Planning Commission Staff Report

Subject: Treasure
Project #: PL-08-00370
Authors: Francisco Astorga, AICP, Senior Planner
Date: 25 October 2017
Type of Item: Administrative – Conditional Use Permit
Refinement 17.2 Update

TOWN LIFT MIDSTATION & CREOLE PARKING PLAN
 SWEENEY PROPERTIES MASTER PLAN

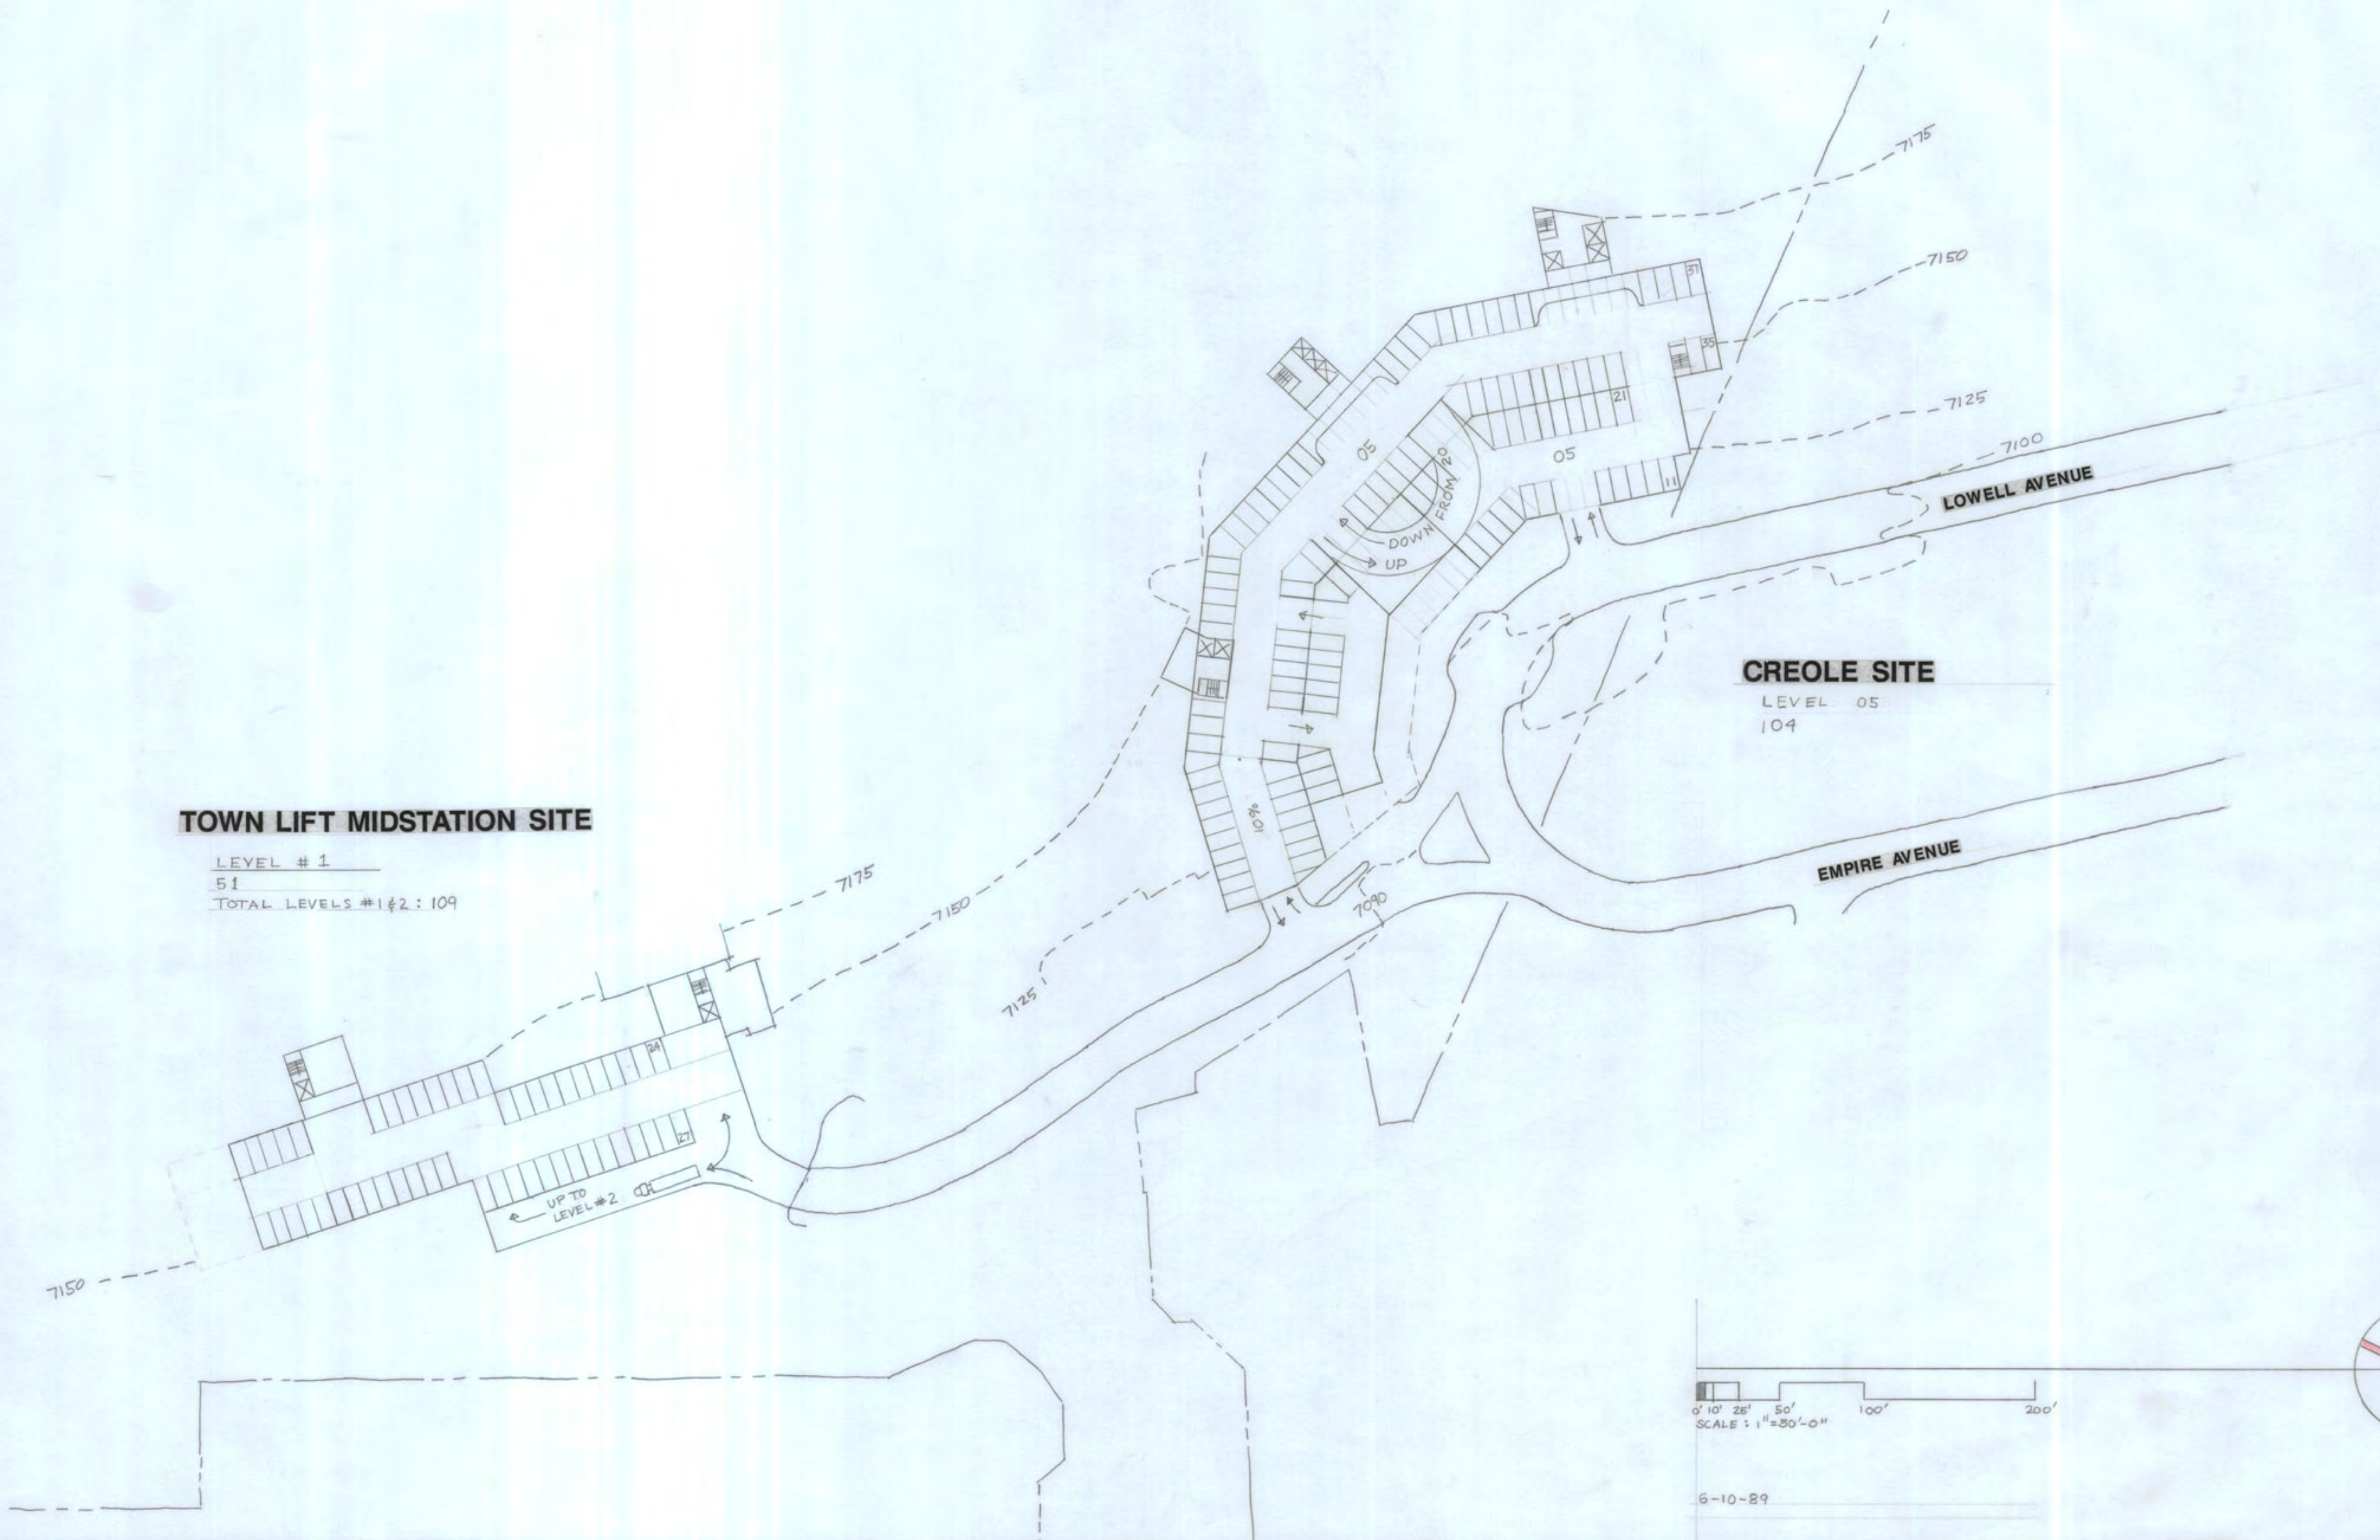
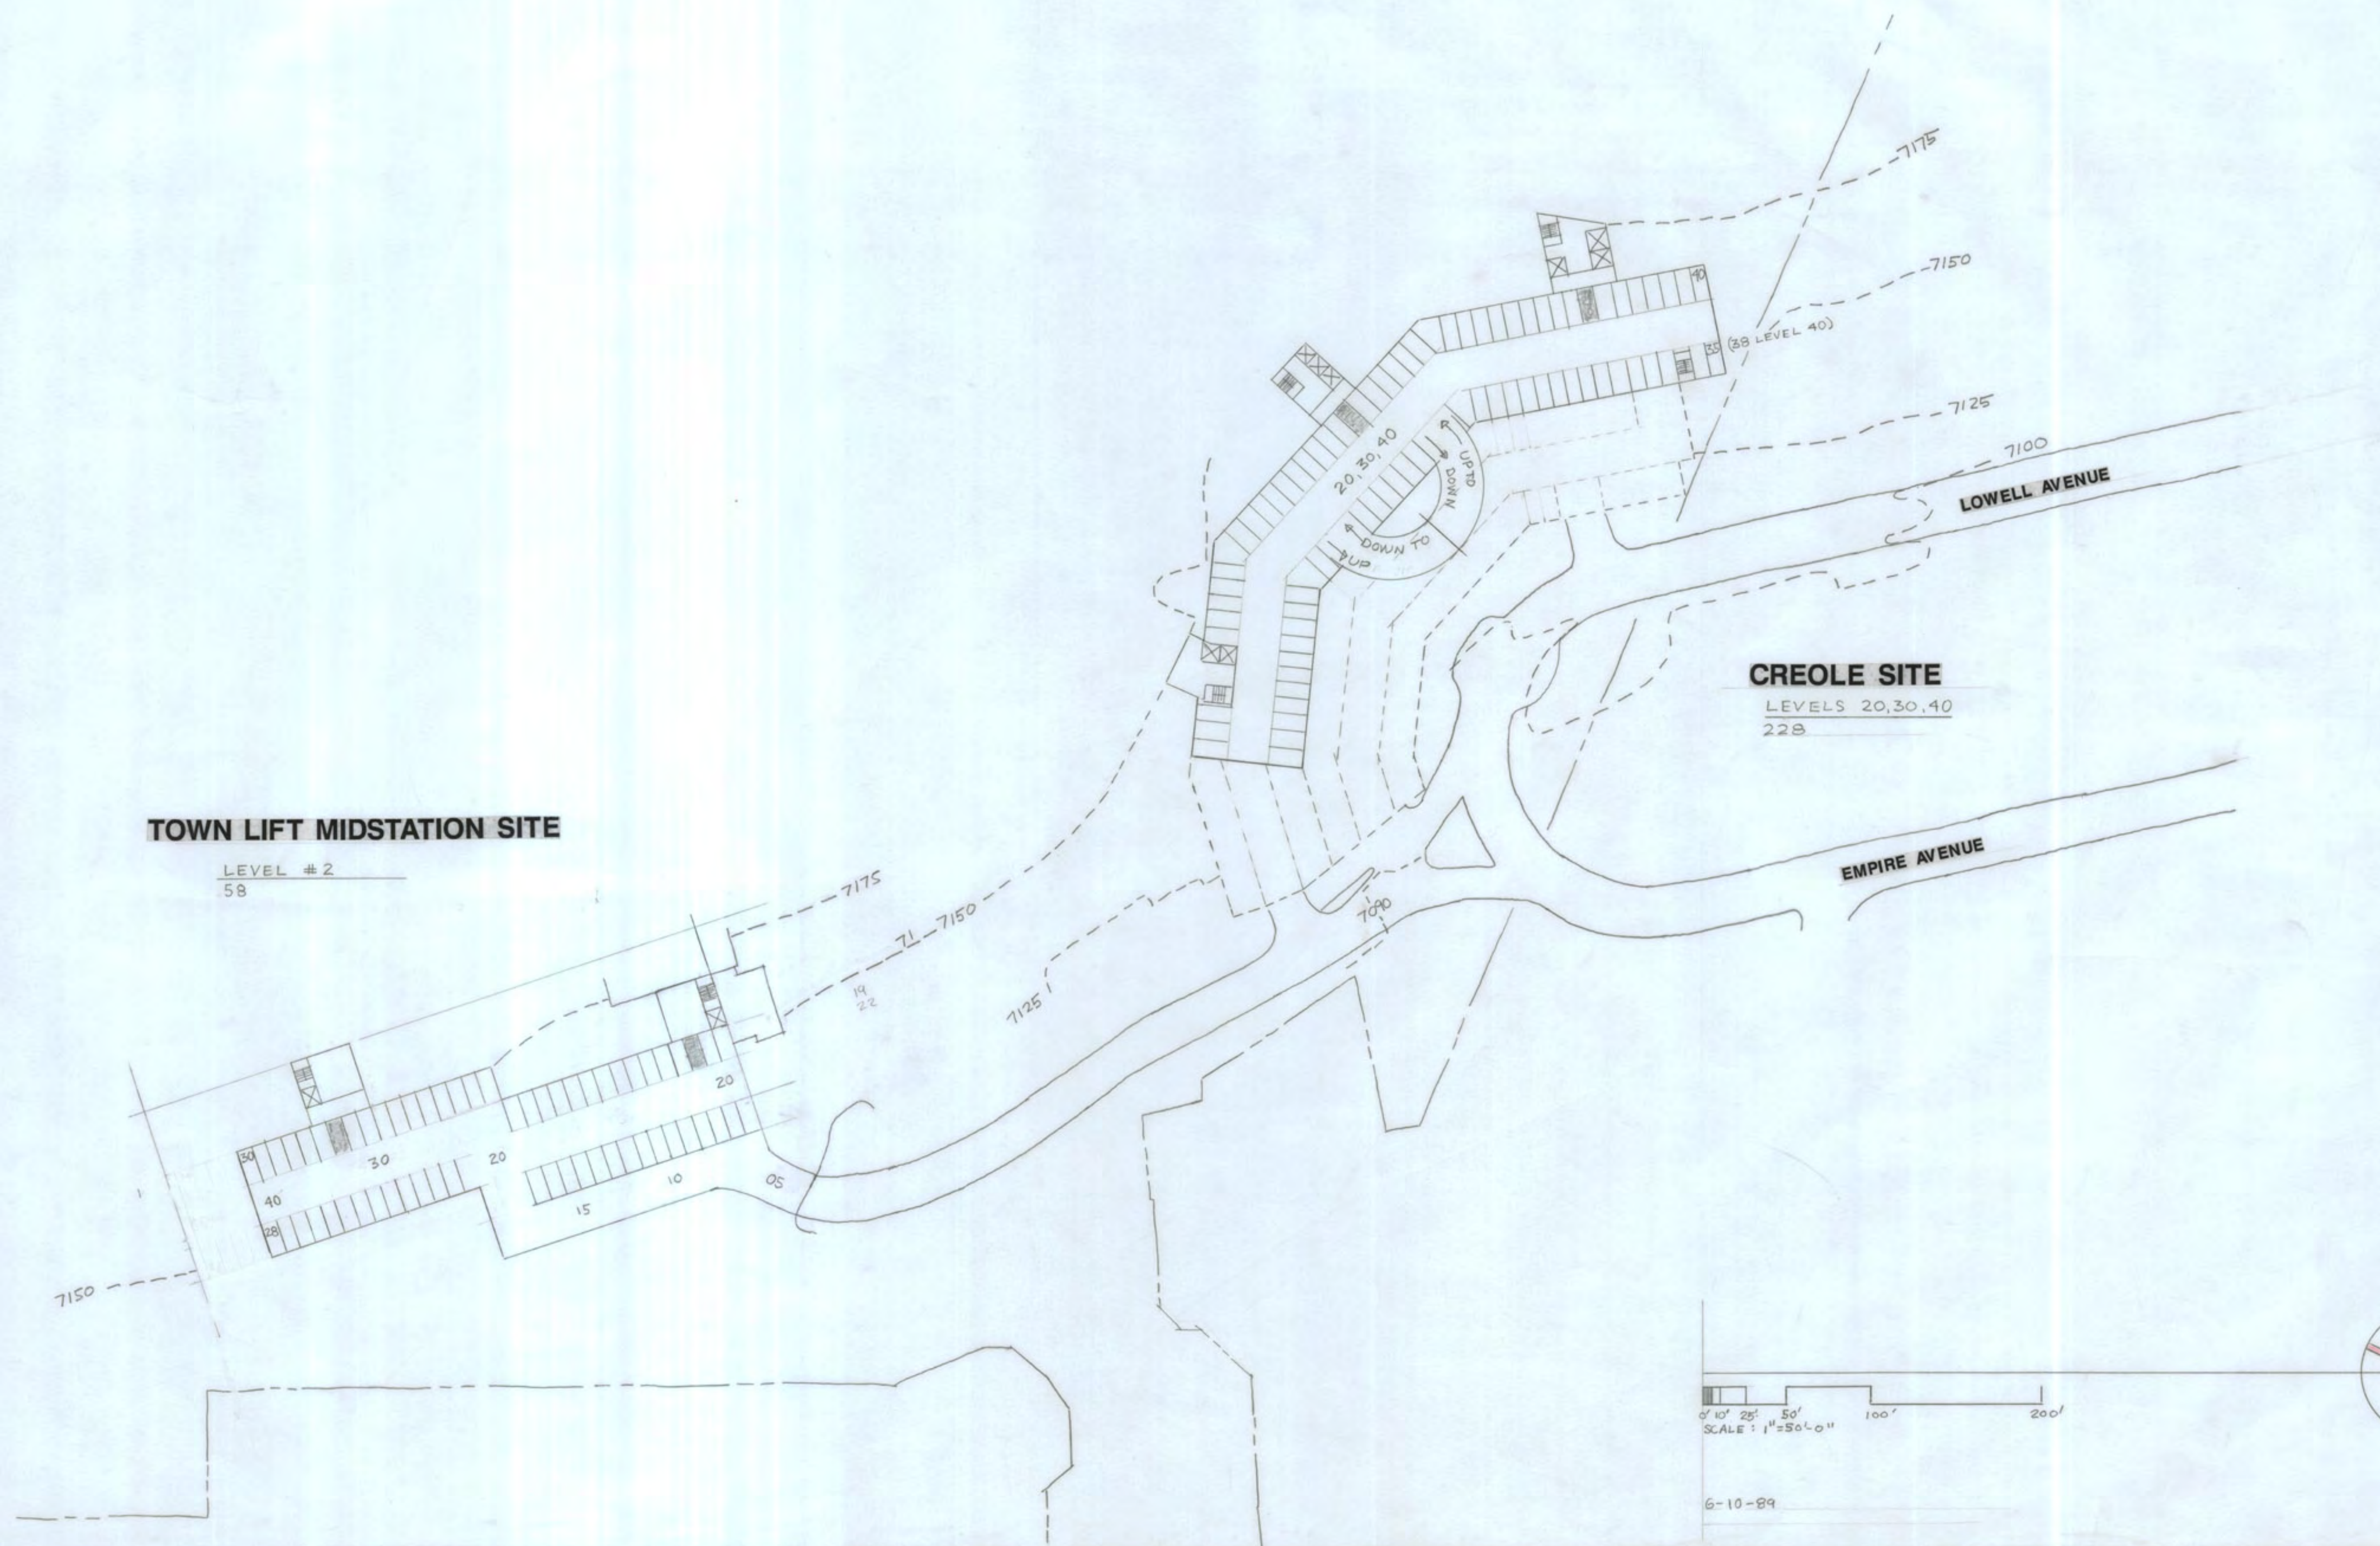
11. The plans include three (3) sheets of parking: sheet 19, 20, and 21.
12. The parking sheets include two (2) levels of parking at the Mid-Station site with 109 parking spaces. Levels connected via one (1) vehicular ramp.

13. The parking sheets include five (5) levels of parking at the Creole-Gulch site with 464 parking spaces. Lowest parking level is identified as the service level and is only accessed off one (1) vehicular entrance/exit. The other 4 parking levels are accessed via two (2) other vehicular entrances/exists and are connected via vehicular ramp system.

14. The parking sheets show the parking garages to be enclosed, towards the front of each building, mostly underground.
15. The Height Zone Plan sheet 22 shows the maximum building height areas/sectors with each corresponding maximum height, number of approved unit equivalents shown on each site, and Table 2: Modified Parking Standard, also Building Area Boundaries.

TOWN LIFT MIDSTATION SAMPLE ELEVATIONS
 SWEENEY PROPERTIES MASTER PLAN

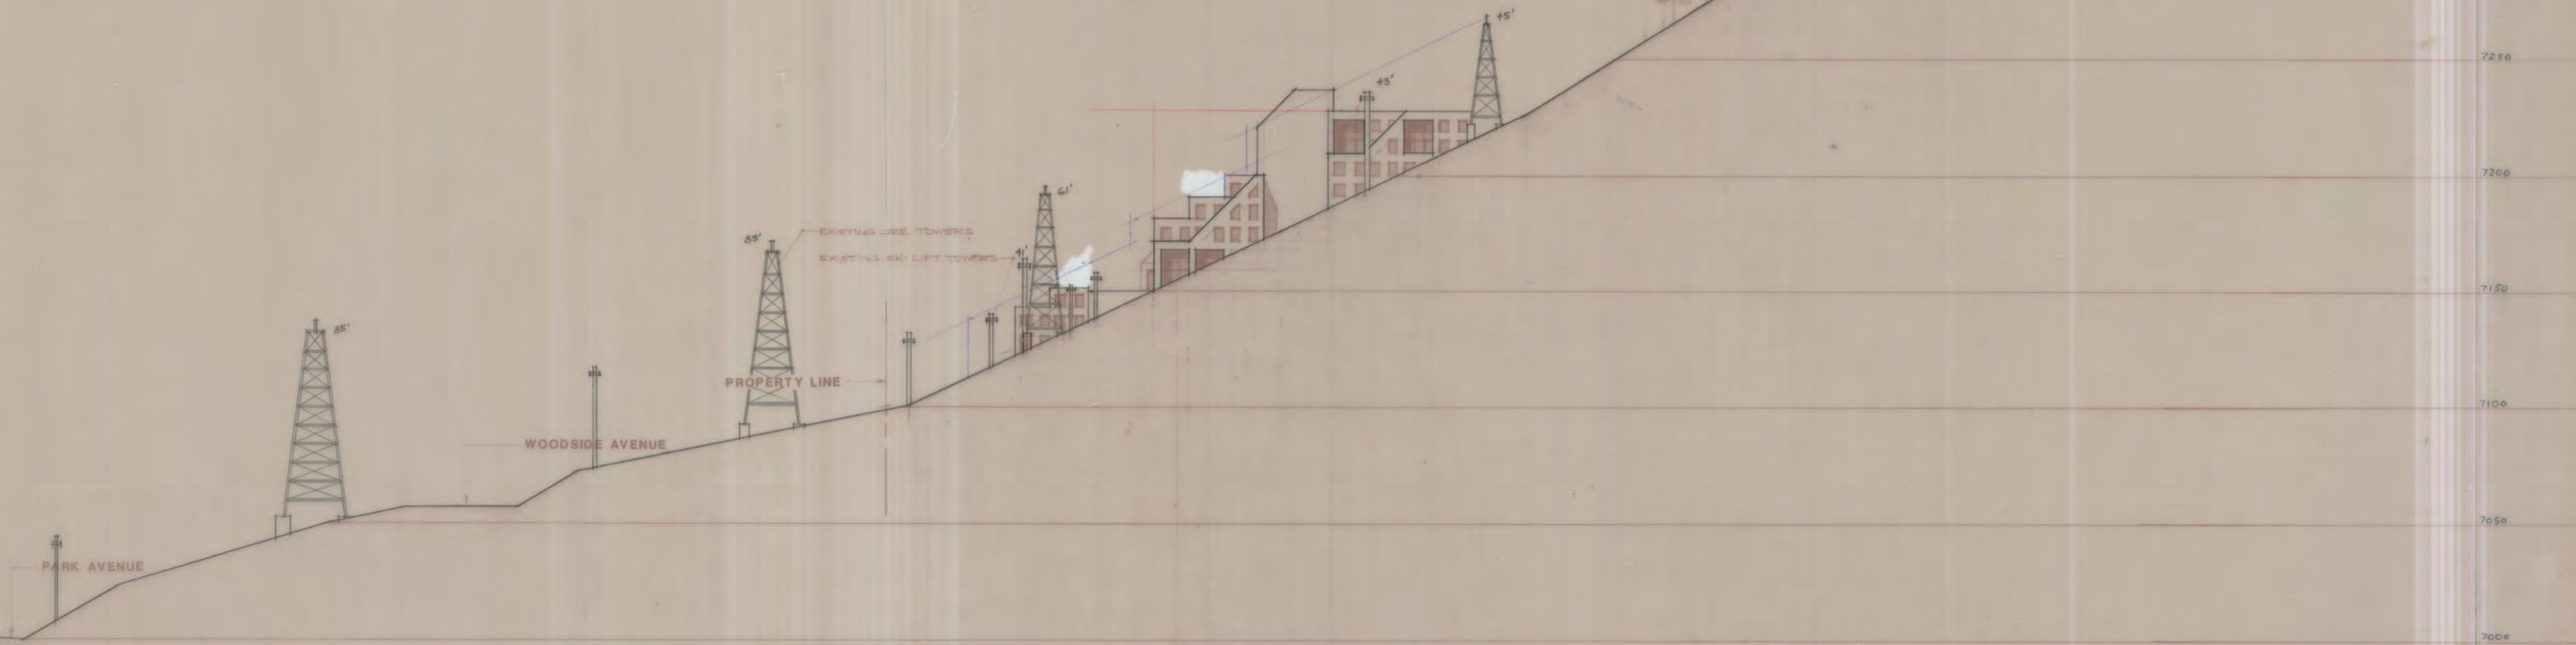
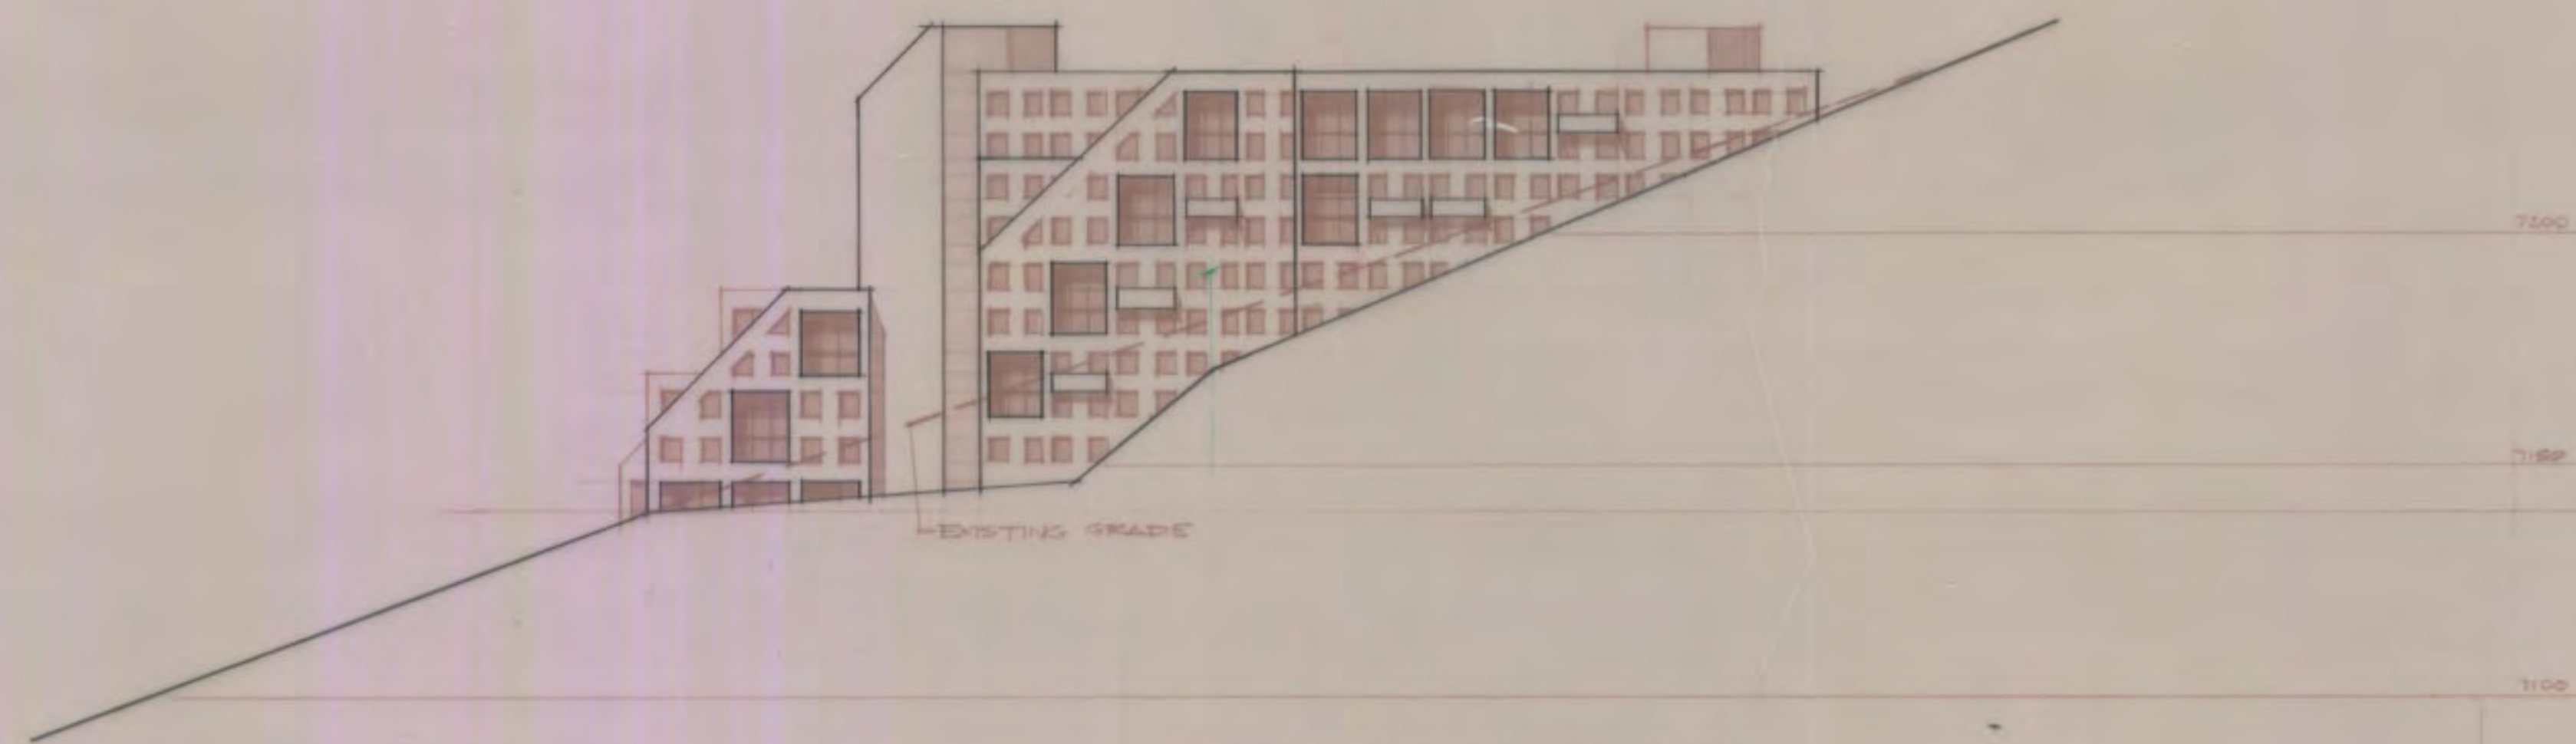
16. Sheet 23 and 24 are sample elevations for both sites.
17. The Mid-Station sample elevations sheet 23, comply with the building sections/height zone plan, measured from existing grade.

18. Sample elevations building A and B are in the Mid-Station site.
19. Sample elevation A shows excavation/re-grading existing grade at the periphery of the structure to final grade about half-way through the building at approximately 14 feet.

20. Sample elevation B does not show any re-grading along the periphery of the building elevation.
21. Sample elevations building C, D, and E are in the Creole-Gulch site.
